Access Compliance Report

Public Rights-of-Way

Intersection ID: 6300	Main Street: JORDANS_POND_LN	Cross Street: VALLEYDALE_RD	Location: S
ADA ID: F0A1170009F6	Ramp Type: BlendTrans1	Initial Pass/Fail: Pass	Overall Compliance: No
Severity Score: 2.75			
Codes/Mitigation Info/Possible Solution		Field Measurements/Component Compliance

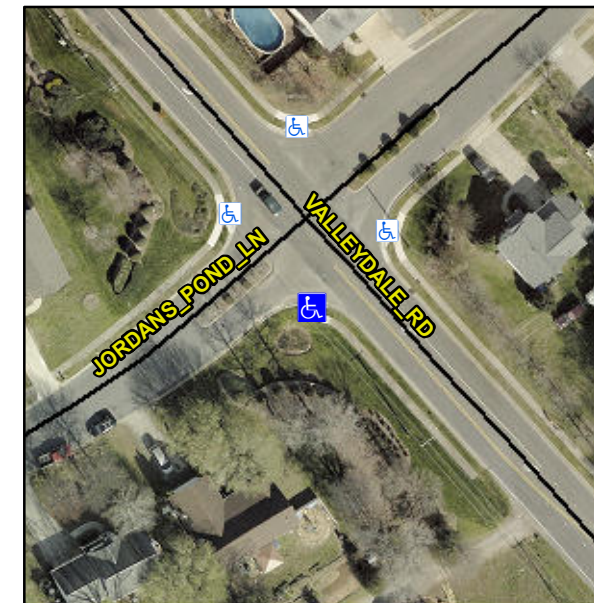
R304.5.3, R304.2.1, R304.2.2-Perp, R304.3.2-Para, R305.1.4, R305.2

Compliance	Description	Data	Compliance	Description	Data
N/A	Ramp Length (in)	54.5	Yes	BlendTrans Slope (%)	2.9
Yes	Ramp Width (in)	56.0	No	BlendTrans XSlope (%)	2.8
N/A	Flare Type LT	Sloped	N/A	Flare Type RT	Sloped
N/A	Flare Slope LT (%)	10.4	N/A	Flare Slope RT (%)	0.8
N/A	Flare Traversable LT?	No	N/A	Flare Traversable RT?	No
No	Landing Length (in)	45.0	Yes	DWS Provided?	Yes
Yes	Landing Width (in)	56.0	Yes	DWS Contrast?	Yes
No	Landing Slope (%)	4.4	Yes	DWS Length (in)	24.0
No	Landing X Slope (%)	4.2	No	DWS Full Width?	No
N/A	Landing Curb? (Y/N)	No	No	DWS Offset (in)	3.0
N/A	Shared Landing?	No			
Yes	Gutter Ponding?	No	Yes	Gutter Slope (%)	4.5
Yes	Gutter Lip Ht (in)	0.0	No	Gutter X Slope (%)	3.8
N/A	Painted X Walk1?	No	N/A	Painted X Walk2?	No
	X Walk 1 Direction	To NE		X Walk 2 Direction	To NW
	X Walk 1 Width (in)	N/A		X Walk 2 Width (in)	N/A
	X Walk 1 Slope (%)	0.5		X Walk 2 Slope (%)	0.2
	X Walk 1 X Slope (%)	2.8		X Walk 2 X Slope (%)	2.1

N/A	Ramp inside XWalk1?	N/A	N/A	Ramp inside XWalk2?	N/A
	Road Slope (%)	2.7		Clear Space?	Yes
	Road X Slope (%)	0.4	N/A	Clear Space to XWalk (in)	N/A
Yes	Any Obstructions?	No	Yes	Storm Grate/Utility Hazard?	No
	Obstruction Type			Storm Grate/Utility Type	
		N/A			N/A
			Yes	Surface Condition? (G/P)	Good
			N/A	Curb Slope (%)	3.9

Remove & Replace Curb Ramp With Two New Directional Ramps or Equivalent. Remove & Replace Gutter.
